RS-04-099

LaSalle County Station, Units 1 and 2

Subject: Supplement to Request for Amendment to Technical Specifications

Section 3.4.11, "RCS Pressure and Temperature (P/T) Limits"

Figure 3.4.11-1 (Page 1 of 1)
Unit 1
P-T Curves for Hydrostatic or Leak Testing up to 20 EFPY

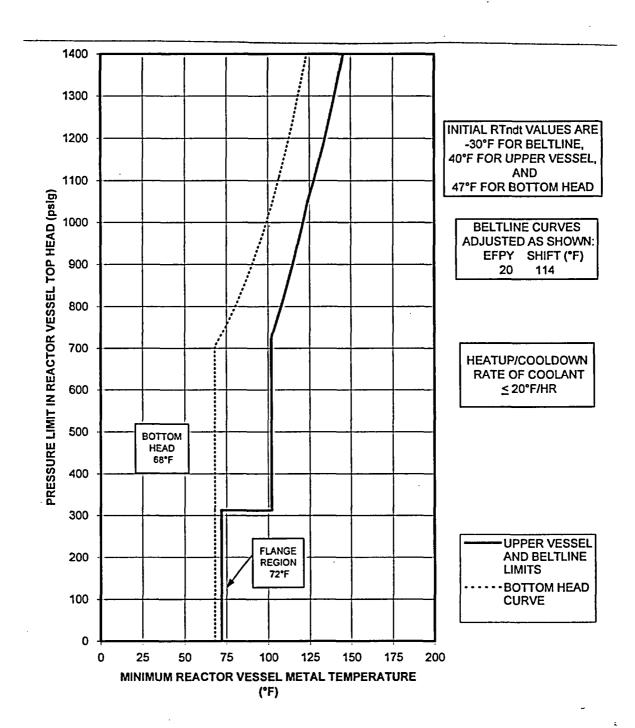
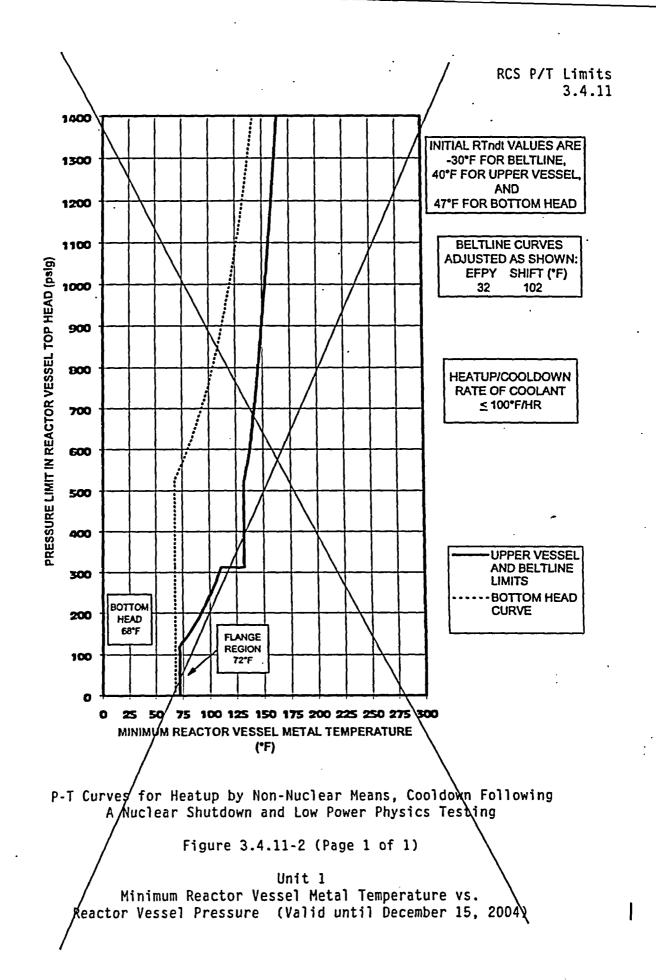
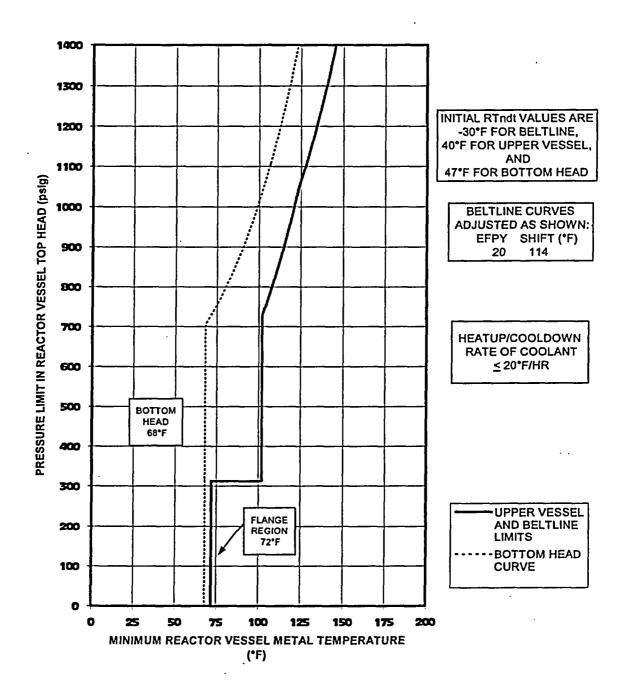
In the referenced letter, Exelon Generation Company, LLC (EGC) requested a license amendment to revise Technical Specifications (TS) Section 3.4.11, "RCS Pressure and Temperature (P/T) Limits," to incorporate revised P/T curves for LaSalle County Station (LCS), Units 1 and 2. Subsequently, the vendor that performed the calculations for the P/T limits, General Electric (GE) Company, identified required changes to the proposed P/T limits and the supporting information.

Attachments 1 and 2 to this letter provide the TS markup pages incorporating the revised P/T limits for LCS. These pages replace in their entirety the TS pages provided in the referenced letter. Attachment 3 provides revised GE proprietary reports supporting the revised P/T limits. These GE reports replace in their entirety the reports provided in the referenced letter. Changes to the reports have been indicated by revision bars, and a summary of changes is provided on Page iii of each of the reports. Attachment 4 provides non-proprietary versions of the GE reports.

Figure 3.4.11-1 (Page 1 of 1) Unit 1 P-T Curves for Hydrostatic or Leak Testing up to 20 EFPY
